**Re: Application to Amend Planning Permit No. PA2503652  
Section 72 of the Planning and Environment Act 1987  
134-138 Moray Street, South Melbourne**

Our client seeks to amend Planning Permit No. PA2503652 (**the permit**), pursuant to Section 72 of the Planning and Environment Act 1987 (**the Act**).

The application seeks an additional level to the approved building resulting in a 10 storey building to a height of 32.69 metres (RL 36.43).

Plan TP02.10 Level 9

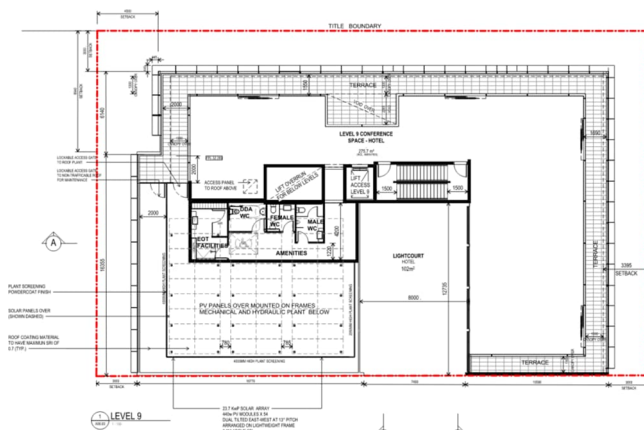
The proposed Section 72 amendment is seeking one additional level to the approved building to a top of parapet height of 10 storeys (RL 36.43) and 32.69 metres. This is less than 4 metres above the preferred building height of DDO39 being 29 metres.

The proposed additional level is 275 square metres in area and set back from all sides of the property boundary and will be imperceptible.

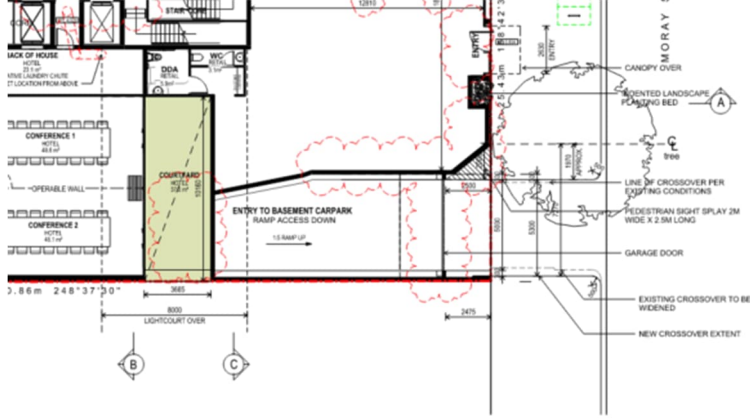
Shadow plans to show the extent of shadow resulting from the additional level, clearly highlighted in context of the existing shadow approved.	A Sun Study (Plan TP10.01) has been prepared by Hayball. The shadow diagrams show that afternoon shadow from the development falls over Moray Street but does not impact the eastern kerb until after 3.00pm. That in our view indicates an appropriate building height is proposed when amenity impacts, such as overshadowing is considered.
Signage – to be included as part of this Section 72 Amendment application (if permit triggered).	Signage that requires a planning permit is not sought or shown on plans. The subject site is in Category 1 – Commercial areas.
Street view renders to understand the true impact of the additional level. Renders are to be at a pedestrian eye height level.	A York Street perspective view has been prepared that compares the approved PA2503652 building with the proposed.

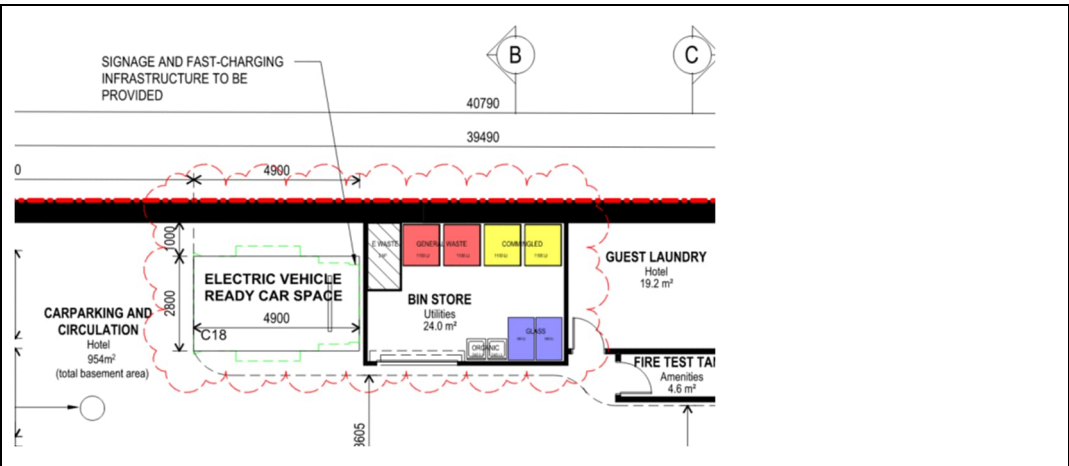
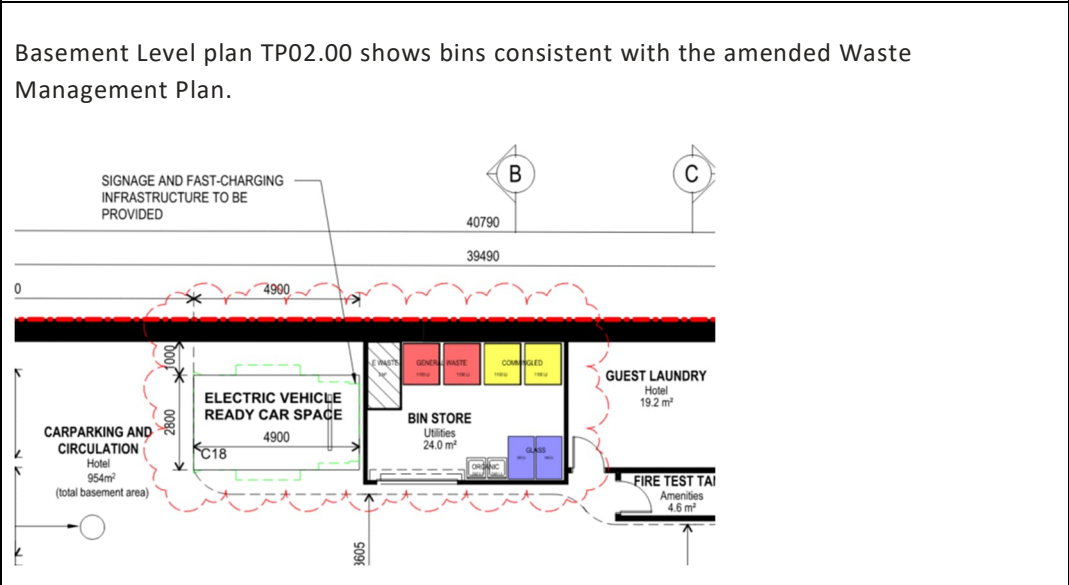
1d) External shading to north, east and west facing windows.	The façade design incorporates vertical and horizontal sunshading devices. The Sustainable Management Plan prepared by ARK Resources has undertaken J1V3 analysis that demonstrates compliance with Performance Requirements J1P1 of NCC 2022.
1e) Electric vehicle ready car space/s to be marked, including signage and	An electric vehicle-ready car space is shown on Basement Level Plan TP02.00. Signage and fast-charging infrastructure are noted on the plan.

fast-charging infrastructure.
